**4TH BRIGADE, 10TH INFANTRY DIVISION
IRAQI ARMY HEADQUARTERS BARRACKS
MISSAN PROVINCE, IRAQ**

SUSTAINMENT ASSESSMENT

**SIGIR PA-08-164
JULY 20, 2009**

SUBJECT: Report on Sustainment Assessment of the 4th Brigade, 10th Infantry Division Iraqi
Army Headquarters Barracks, Missan Province, Iraq (SIGIR Project Number PA-08-
164)

Figure 1. Government Furnished Design C-001 site plan showing the existing and proposed buildings

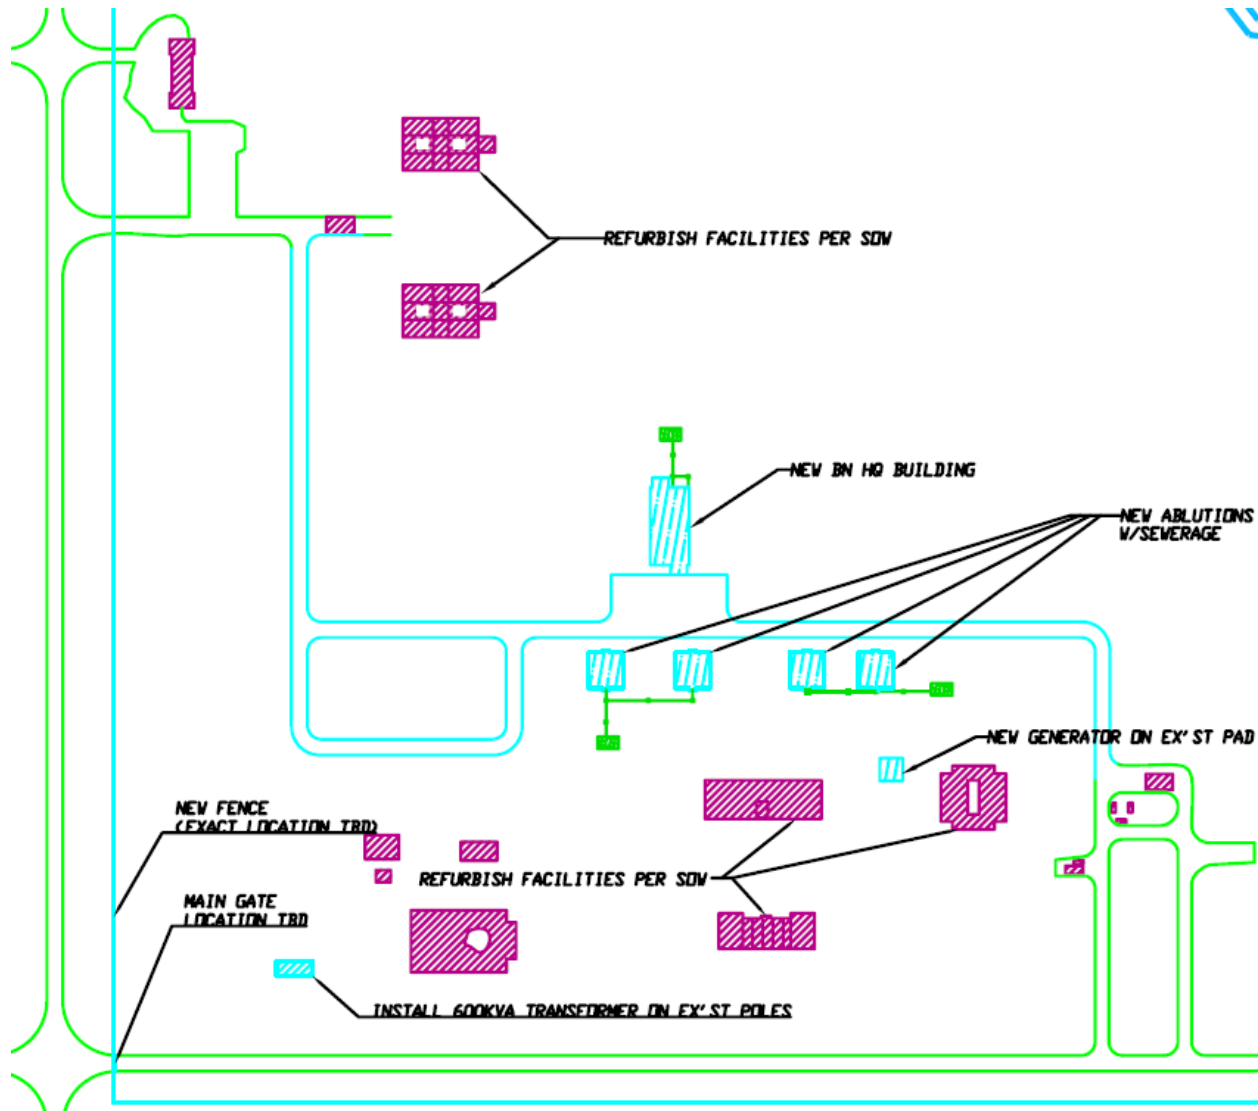
The project documentation provided by GRS did not include detailed construction drawings or design calculations for the project. SIGIR obtained and reviewed some Government Furnished Drawings (GFDs) provided to the contractor: the GFDs included a site location map (Figure 1), a rough site layout, general notes, septic tank details, and roadway cross-section details. A list of the GFDs provided to the contractor was included in the SOW.

The project documentation clearly identifies specific drawings that were to be supplied to the contractor for use during construction. The GFDs provided to SIGIR were determined to be adequate to outline the scope of the project for the contractor but were not adequate to construct the project. SIGIR requested additional contractor-furnished drawings from both GRD and GRS, but neither was able to locate the design drawings. The lack of available design drawings limited the ability of SIGIR to determine the adequacy of the project's design. However, the detailed list of specifications provided in the SOW did provide GRS with a limited basis for requiring the contractor to meet some minimum standards during the construction of this project.
